G.O., No. 386

Buildings — Requesting the Director of Public Instruction to instruct the school authorities at Muthialpet to carry out the suggestions made by the Chief Engineer with regard to the extensions to the High school building there.

24 tensions to the building occupied by the Mouthialpet High school.
Madras - Forwarding with remarks copy of a letter from the 24. Engineer
Presidency Division saying that the building is not safe.

Extensions to the Muthialpet High School
Building, Madras.

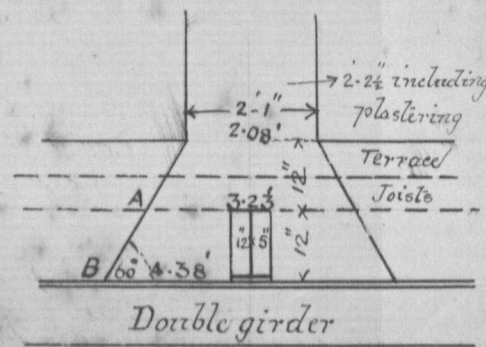
3. The soil is sandy, but mixed with so large a proportion of earthy matter as to approximate to loam, and had I been consulted beforehand I should not have passed it for a pressure of $2\frac{1}{2}$ tons per s.ft. The superstructure, however, seems sound enough at present, though it has still to receive the roof and it has still to be seen how the soil will behave under variations of humidity and temperature.

4. In other respects the building appears to have been built according to plan, and is therefore open to the criticisms contained in your Note No. 62-C dated 3-1-13 except that the girders referred to in para 4 of your Note are, as a matter of fact, 14" x 6".

5. Also, on the Sub Division Officer's suggestion, which I supported, the builders propose to bring the gable roof right up to the facade, which will slightly reduce pressures.

6. The Executive Engineer's criticisms of the staircase are sound, but inasmuch as the staircase is not only standing, but has been ~~pretty~~ pretty severely tested by a crowd of coolies carrying up the ~~MI~~ C.I. columns for the top storey, its demolition need not be insisted on. The staircase moreover is only temporarily needed, for the adjoining property (Southwards) has been purchased and it is proposed to build another half to the building as shown on the accompanying pencil sketch, when the staircase will be replaced by a central main staircase as shown in the sketch.

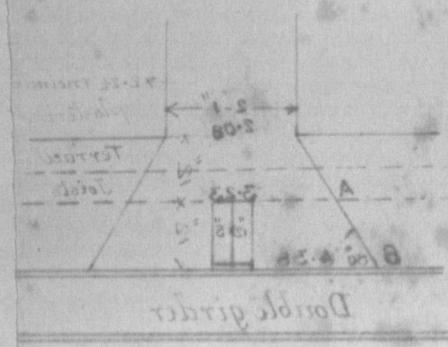
7. Apart from the unknown and probably overloaded foundations the weakest part of the building is the pillar marked P-6 on the blue print (see para 2 of your Note above-quoted). Since this pillar has not been enlarged the pressures at its base (assuming an imaginary line of spread of 60°) work out, according to calculations made in my office, to 6.20 tons per s.ft. at A (marginal sketch) and 4.57 tons at B, the width of the pillar (at right angles to the plane of the paper) being 1'-10 $\frac{1}{2}$ " and of the wall (on the double girder) 1'-11 $\frac{1}{2}$ ".

There is no cure for this but to pull the whole front of the building down and redesign it or rebuild the over-loaded parts in cement.

(1) The staircase should be demolished and rebuilt.

(2) The pressures on the piers and external wall, and on the soil under them should be relieved by carrying the weight of the first floor and second floor on stanchions placed against the piers and wall in the manner indicated on the accompanying diagram. C.A.93/1913. This diagram represents the treatment proposed for the pier P.1. but the treatment of the five other piers (vide ground plan) and of the seven points of support of the 12 x 5 x 32 lbs girders in the external wall will be similar.

All new work should be built in quick setting cement.

(3) The pier P.6 on first floor, with its super-incumbent load should be demolished and rebuilt. Below P.6 a new pier should be constructed (on the ground floor) with suitable foundations, in order to relieve pressure on the over loaded pier P.1.

The weight of the first floor and second floor transmitted to P.6 may be carried on stanchions as recommended in the case of the other piers and external wall. There will thus be required 14 stanchions on the ground floor and 14 on the first floor.
